Motorcycle Service Bulletin – SBMCAP1501

SUBJECT: NBC110 Steering Stem Inspection

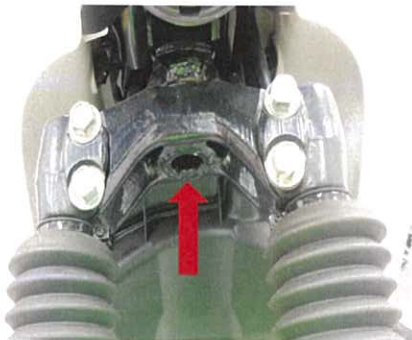
It has come to our attention that an issue may arise concerning the integrity of the weld on the base of the steering stem on the NBC110 Australia Post units. At present this is an isolated case whereby the forks were able to drop away from the steering stem.

In the interest of rider safety it is advised that the front forks are checked for movement and the welded area, shown below, is visually checked for damage or cracking as part of the pre ride inspection.

The following photos show the area of concern.

If movement of the forks or cracking of the weld is detected the unit should not be ridden and the appropriate personnel are advised to organise the repair.
